| Reference:        | 18/00087/UNAU_B  |  |
| Breach of Control | Without planning permission the installation of an external staircase to the rear elevation and erection of rear outbuilding |  |
| Address:          | 81a Silverdale Avenue, Westcliff on Sea, Essex. SS0 9BB  |  |

# APPENDIX 'A'

View of stairs showing storage area

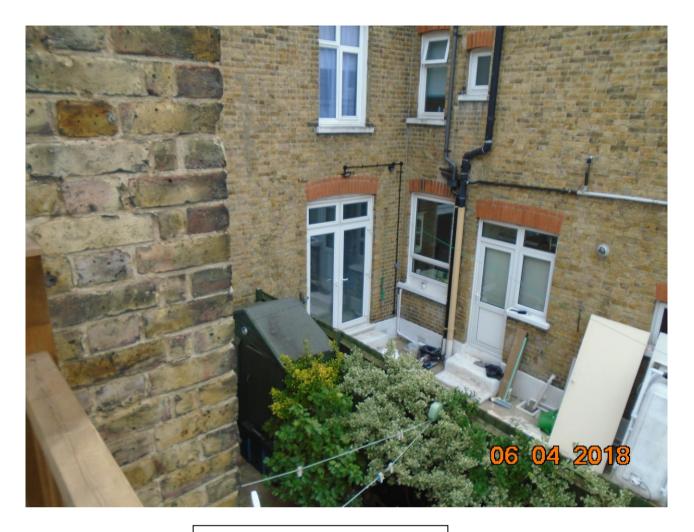
- 4.9 The proposal also includes a substantially built wooden external staircase to the rear which extends the full width of the rear wall of the outrigger and is some 4.4m high. The staircase has timber vertical supports and wooden railings, with a platform at the upper level some 2m wide and 1.75m deep which facilitates the opening of the rear door outwards. The formation of a storage area with the area under the staircase considerably reduces the openness to the rear and has the appearance of a permanent 'extension' at ground floor with the staircase above. Therefore the staircase structure forms a visually harmful, bulky, incongruous and excessively dominant and oppressive feature which is out of scale and character with the rear garden scene. The absence of any rear access to the existing first floor flat, particularly as a means of escape has been considered, however this does not outweigh the material harm caused by the impact of the staircase as built.

- 4.15 The rear staircase extends across the full width of the rear outrigger. The outrigger currently extends some 4.6m beyond the rear wall of the neighbouring dwelling at No. 83 (to the north). The neighbouring property has been extended at ground floor, with a rear conservatory present. The staircase would extend another 1.75m beyond the end of the outrigger. From the top platform of the staircase it is possible to gain a full view of the rear garden and the rear of the neighbouring property, into the conservatory.

- 4.16 From the southern side of the top platform and to some extent the lower levels of the staircase, a full view of the rear garden and rear elevation of the neighbouring flat and the side elevation of No. 79 is obtained. 1.8m high privacy screens could be added to each side of the top platform of the staircase to mitigate the overlooking, however this is considered to be unacceptable in design terms as this would add even further to the unacceptable prominence and bulk of the staircase and would be out of keeping the rear garden scene.
